Re: A & J Cartage Site Plan Review letter dated January 19, 2022

Re: A & J Cartage Site Plan Review letter by SAFEbuilt dated January 20, 2022

Re: A & J Cartage Site Plan Review No. 1 dated January 19, 2022

SITE PLAN FOR A & J CARTAGE

TITLE
LARGE VEHICLE CIRCULATION PLAN & LIGHTING PLAN

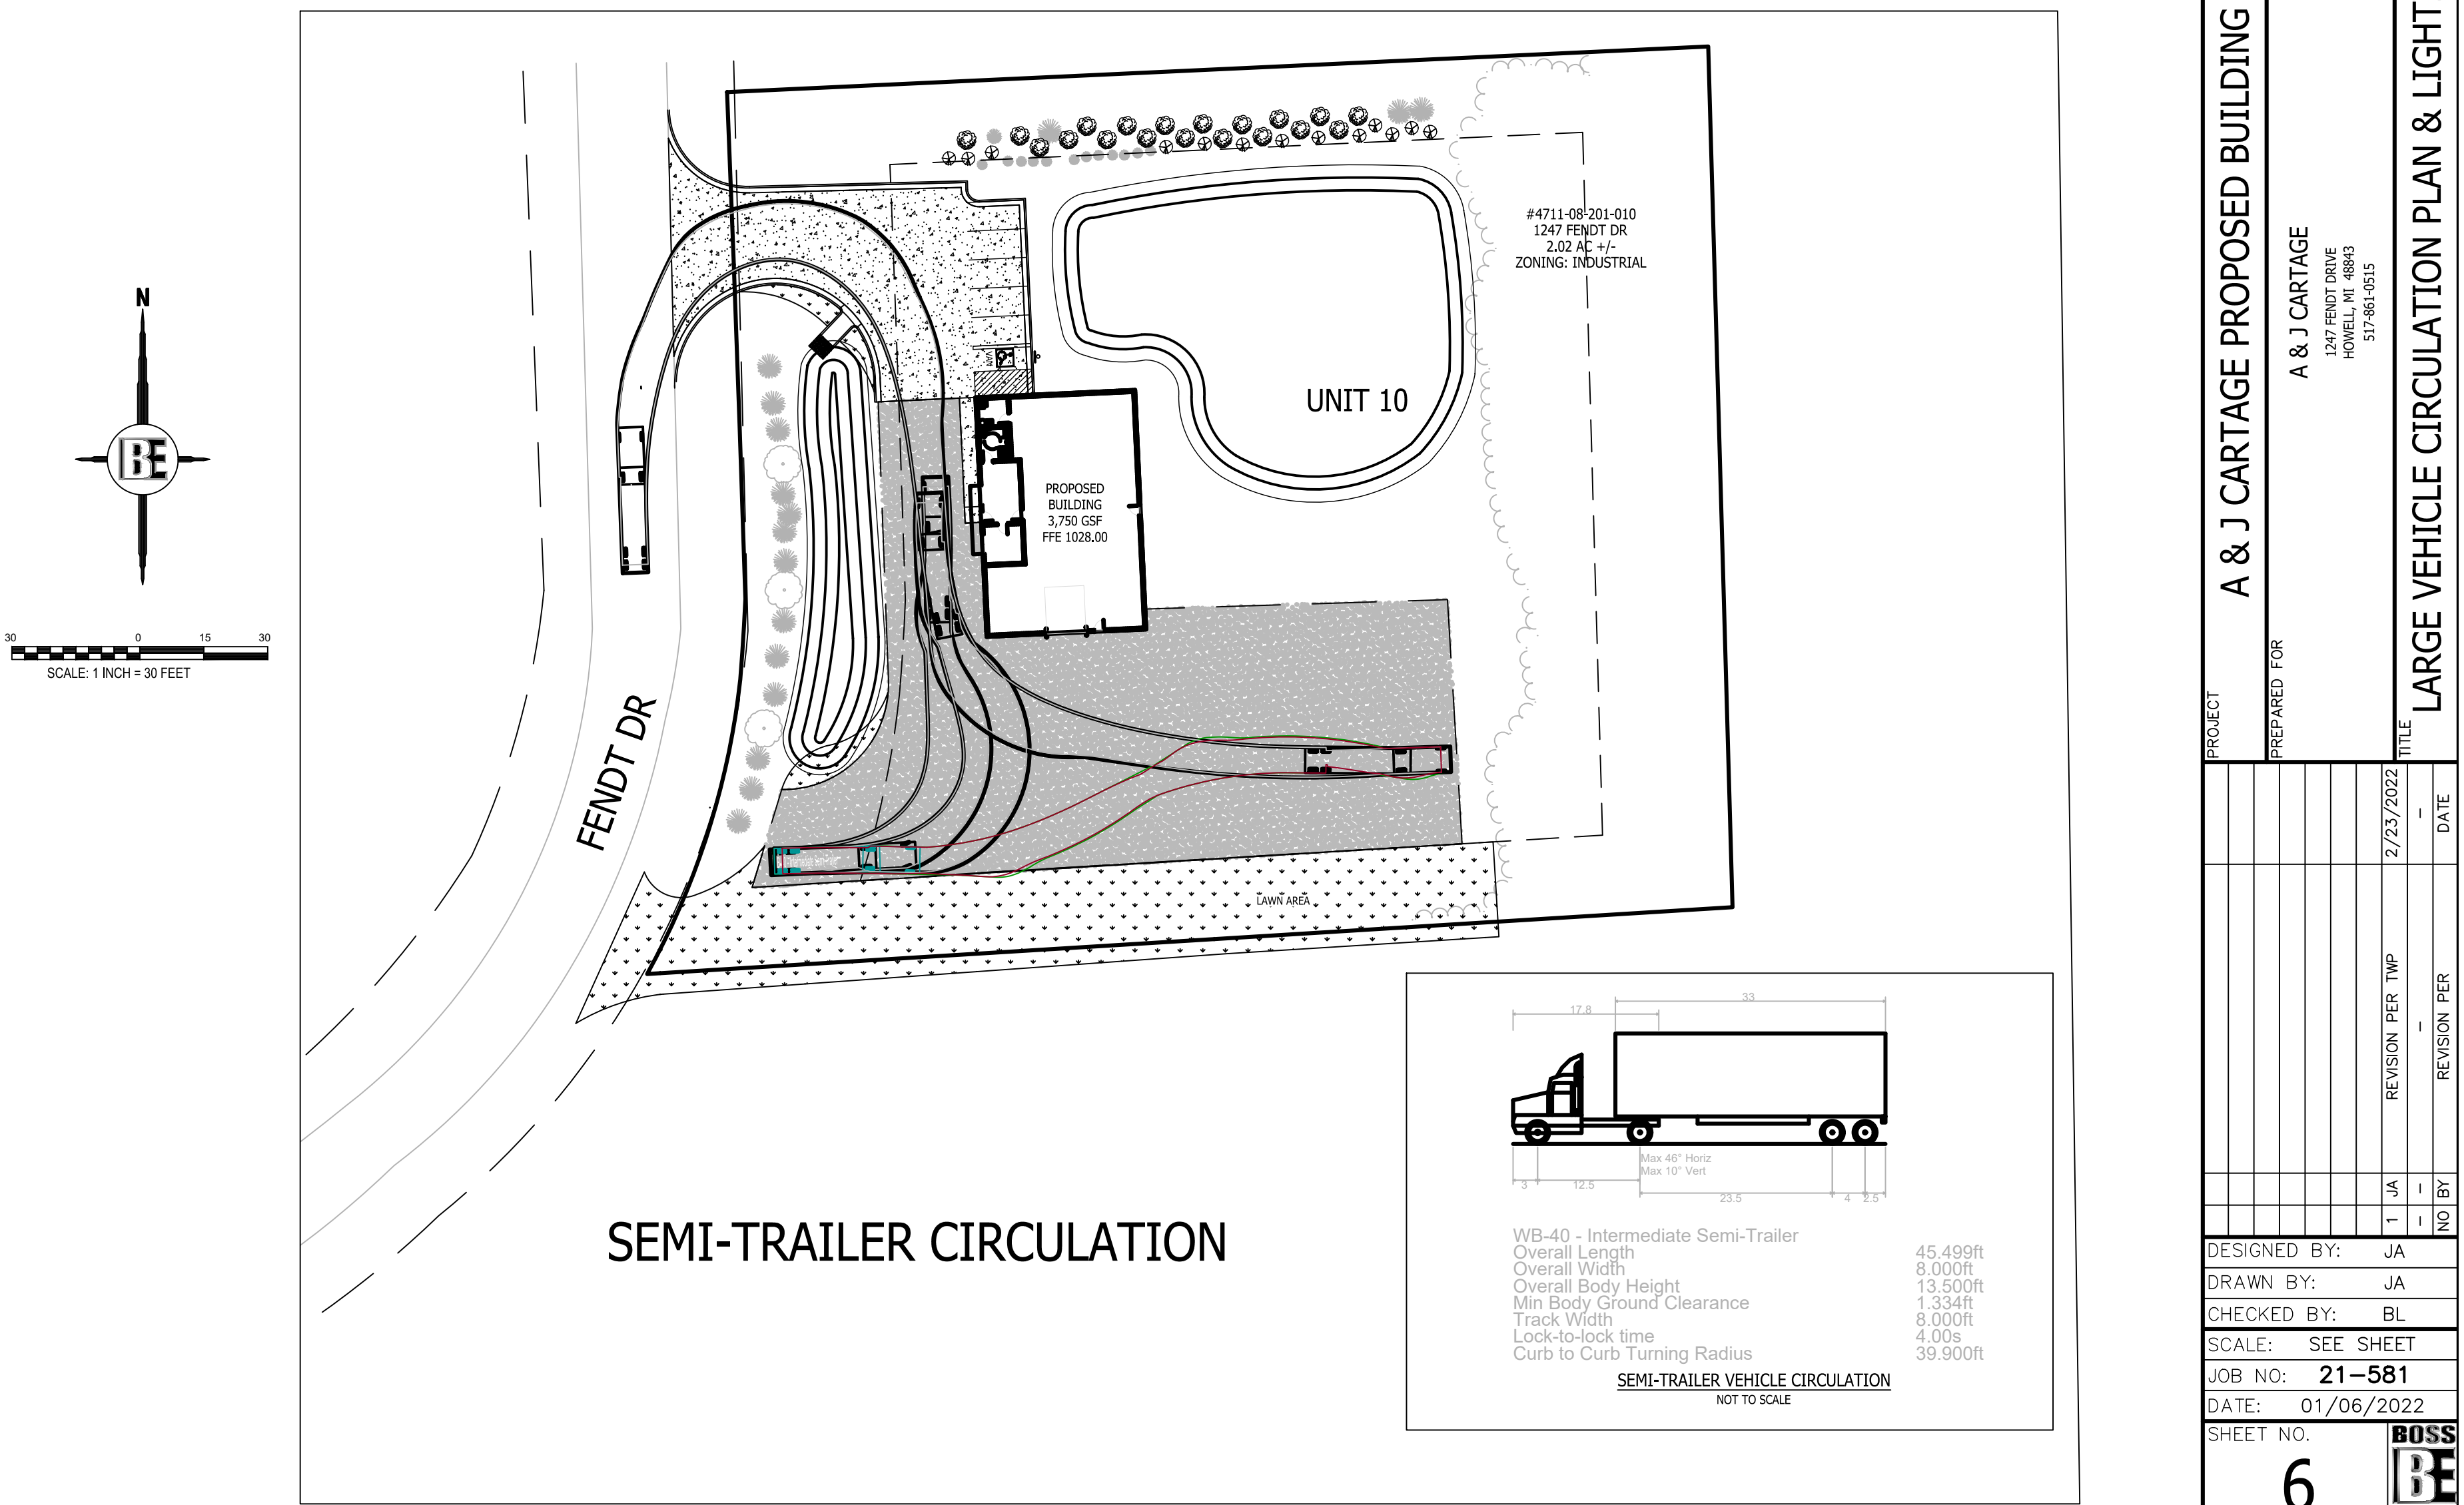
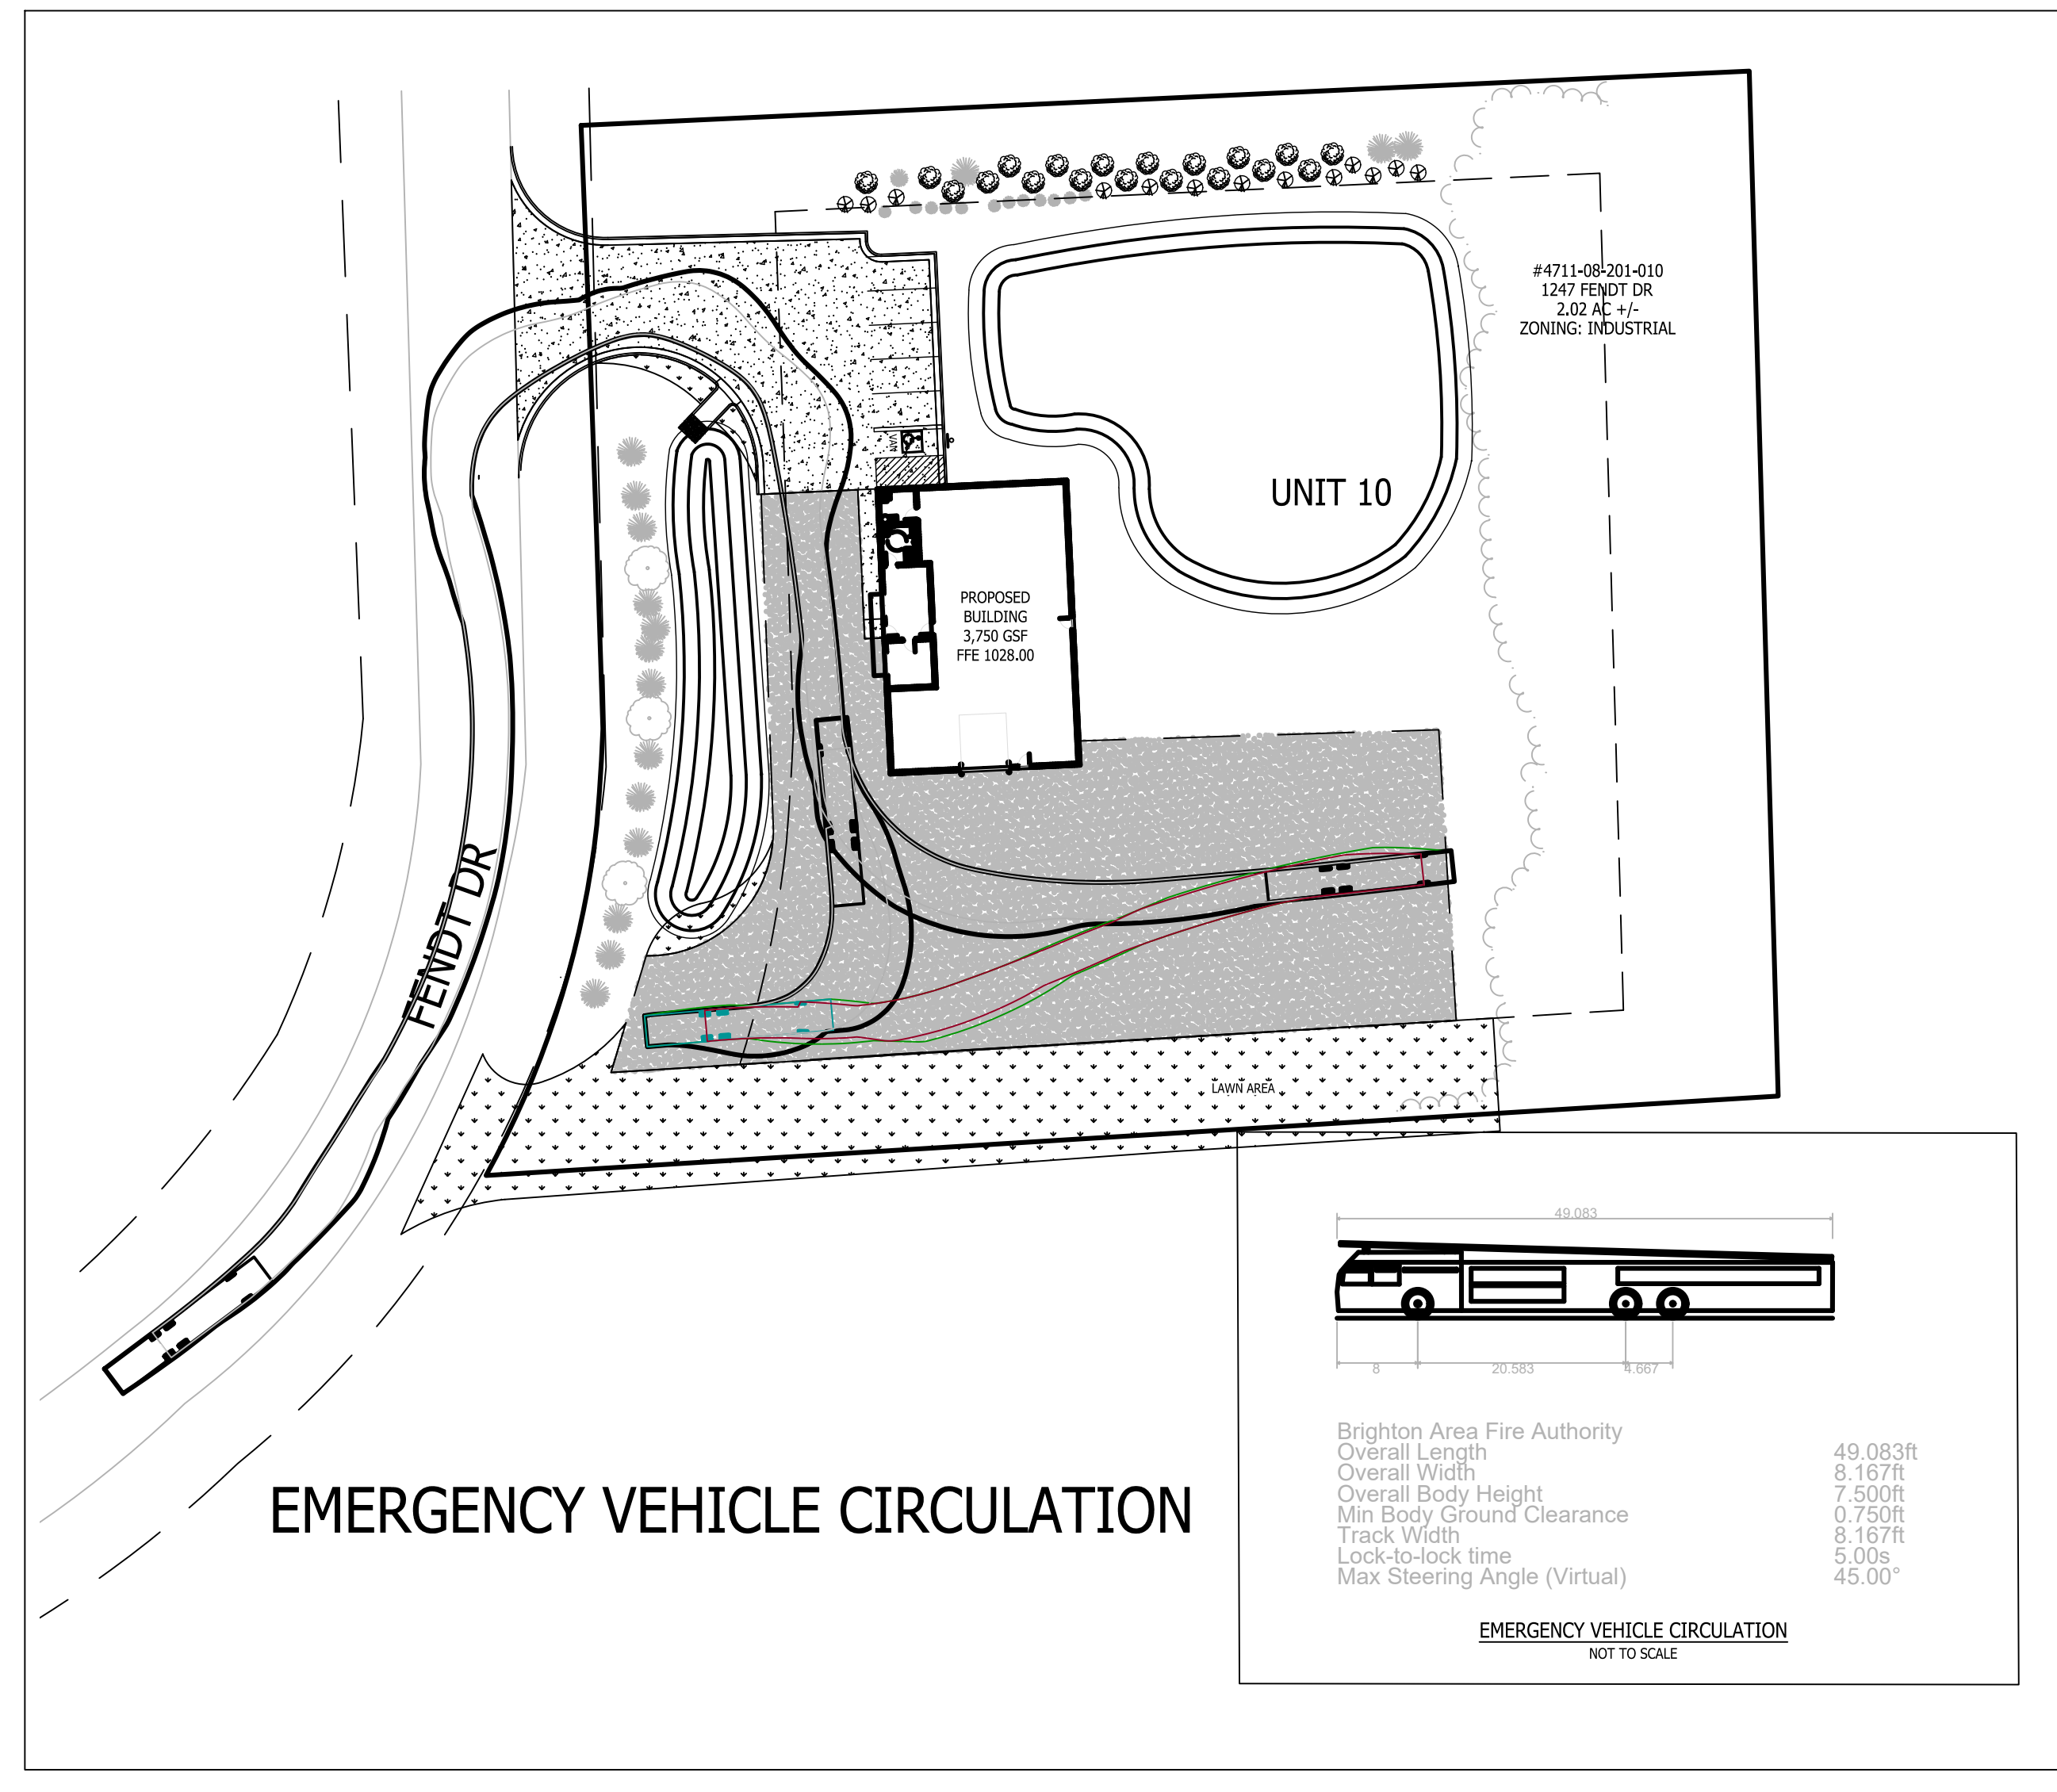
4. No outdoor storage will be within the required 25-foot side yard setbacks nor any other required yard setback (See note on Site Plan Sheet 3.)
6. An additional tractor-trailer truck turning template has been added to Circulation Plan Sheet 6 as requested to demonstrate truck maneuvering on-site.

TITLE: CONSTRUCTION DETAIL

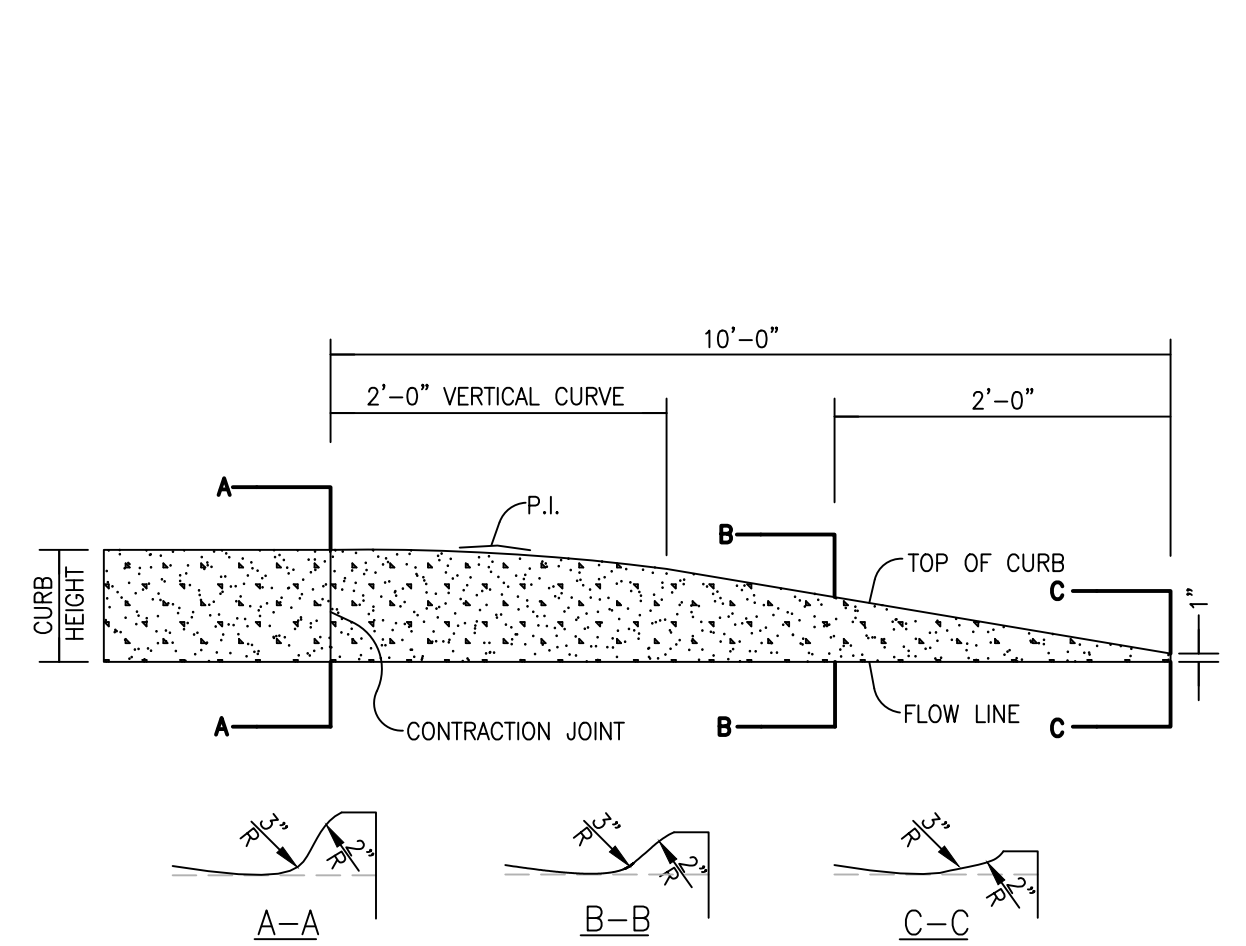
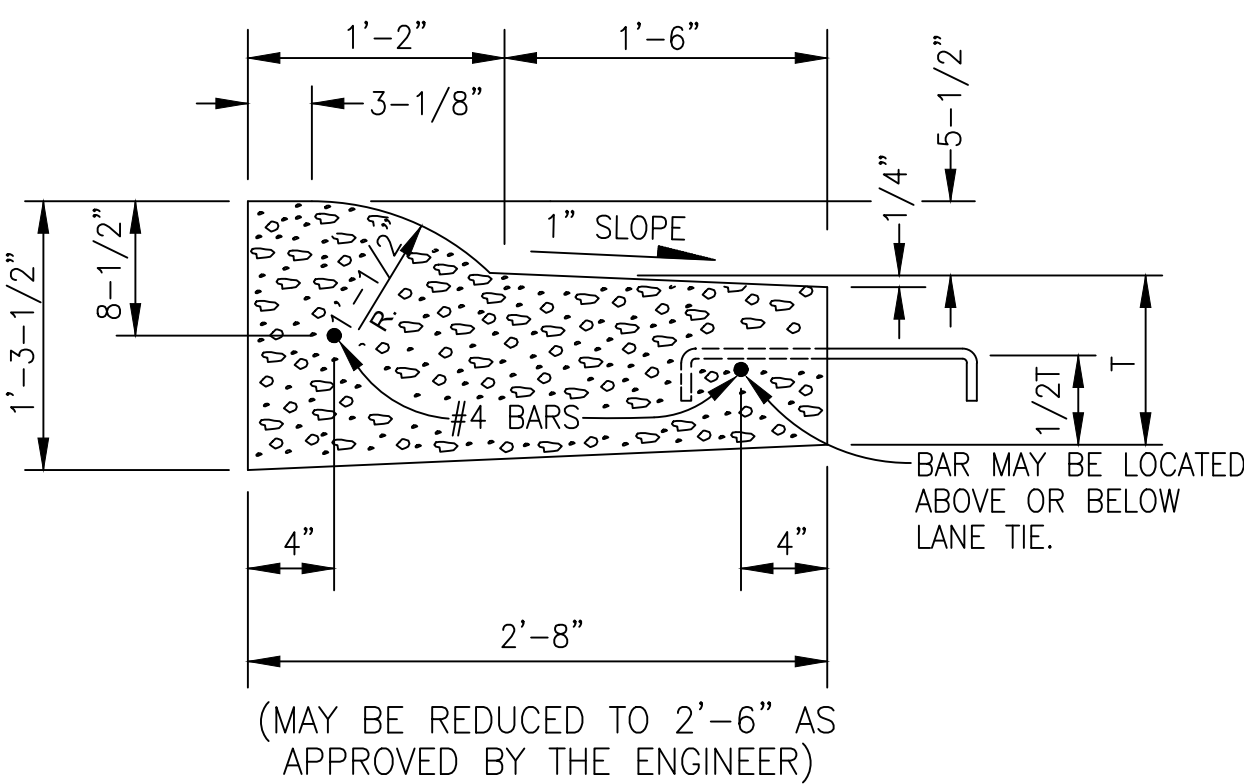
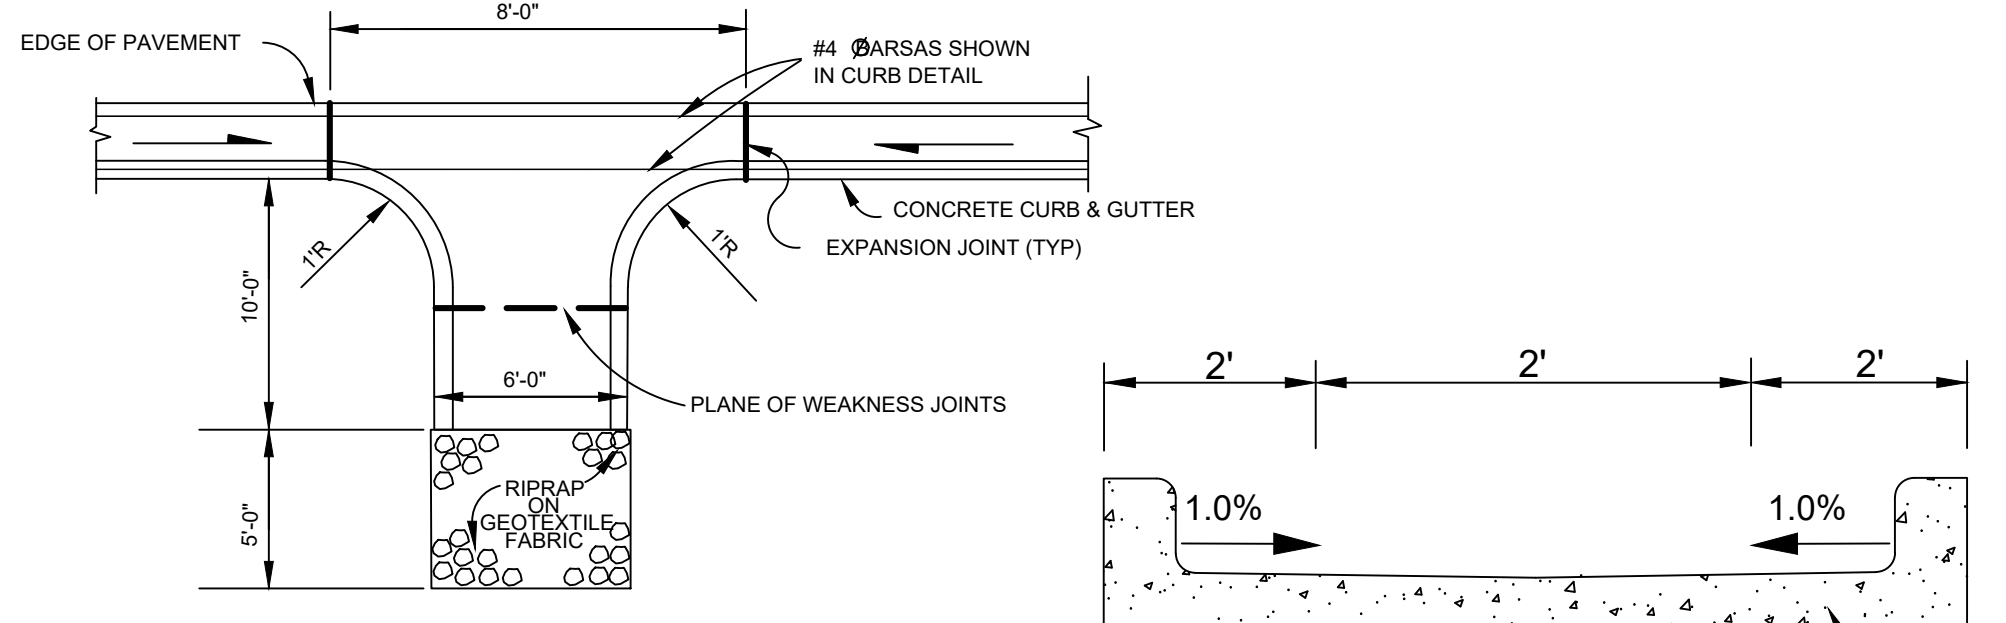
7. Sanitary Sewer Service notes on Detail Sheet 7 have been updated.
